REMARKS

ANNOTATED SHEET SHOWING CHANGES
 Frequency Synthesizer having PLL with an Analog Phase Detector
 Serial No. 10/713,717
 Response to Office Action mailed April 13, 2005

Fig. 4

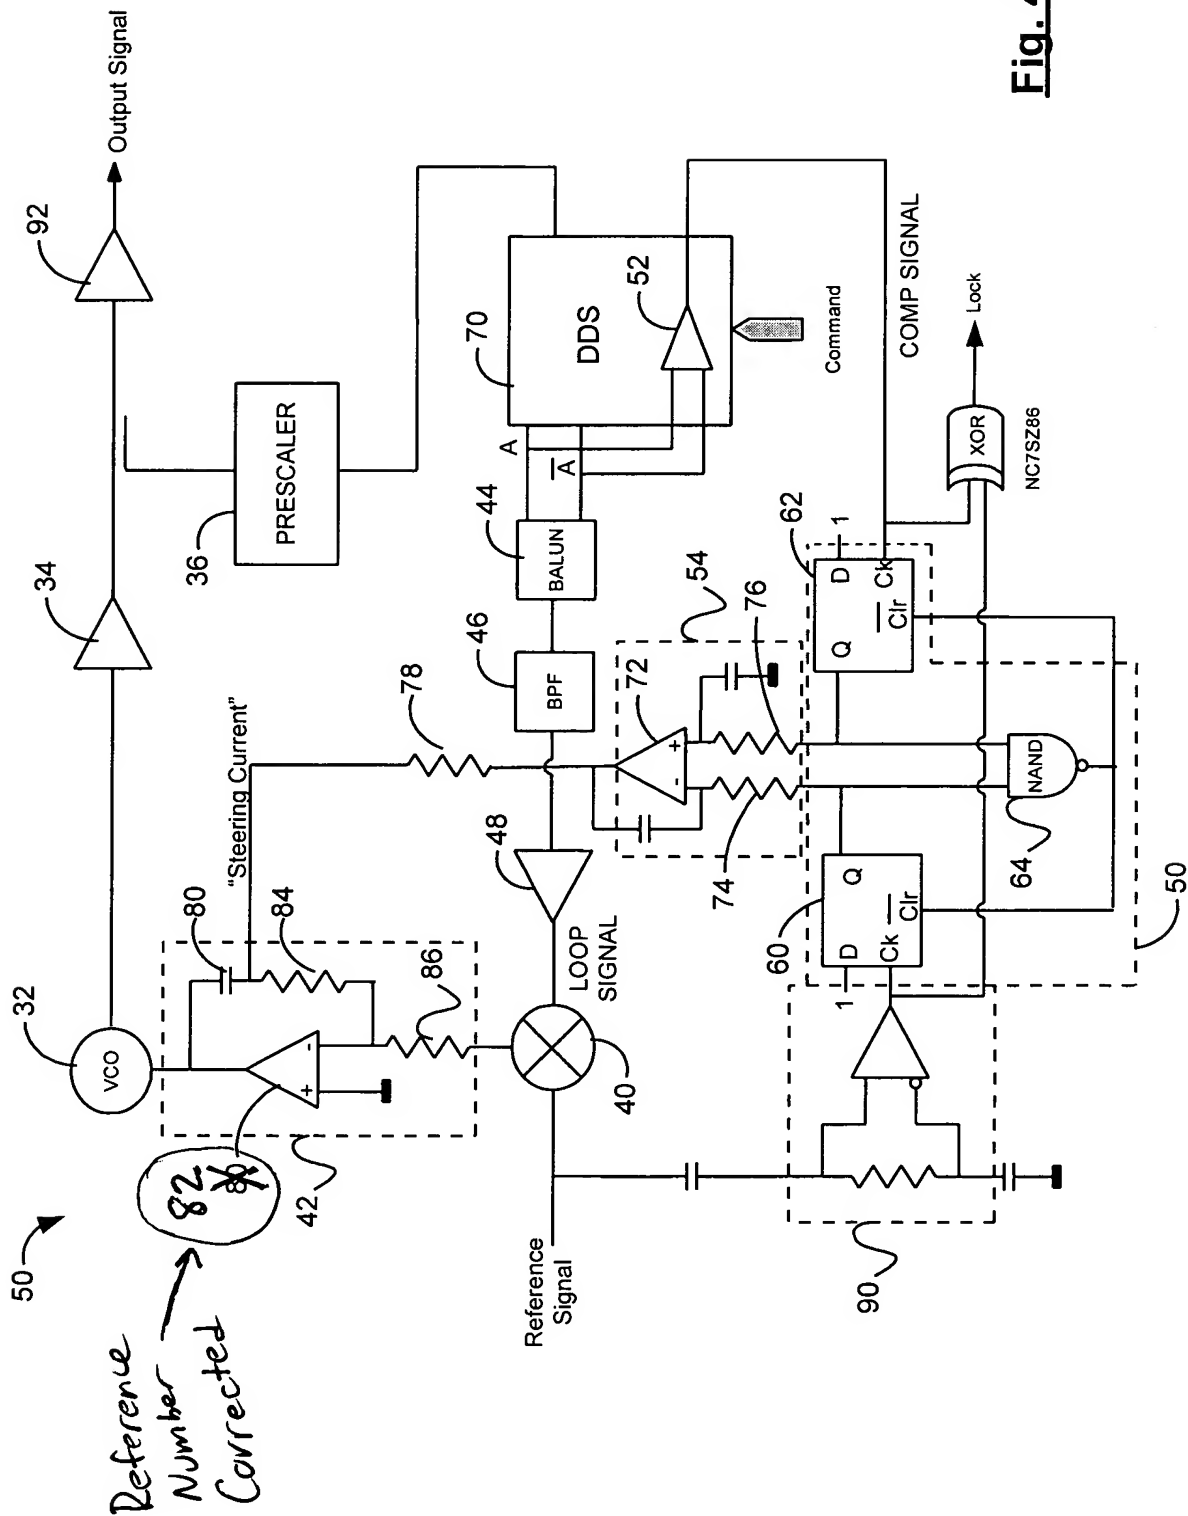
Although not objected to in the Office Action, Figure 4 has been amended to correct a clerical error. The operational amplifier that is part of the loop filter 42 should have the reference number “82”, not “80”.
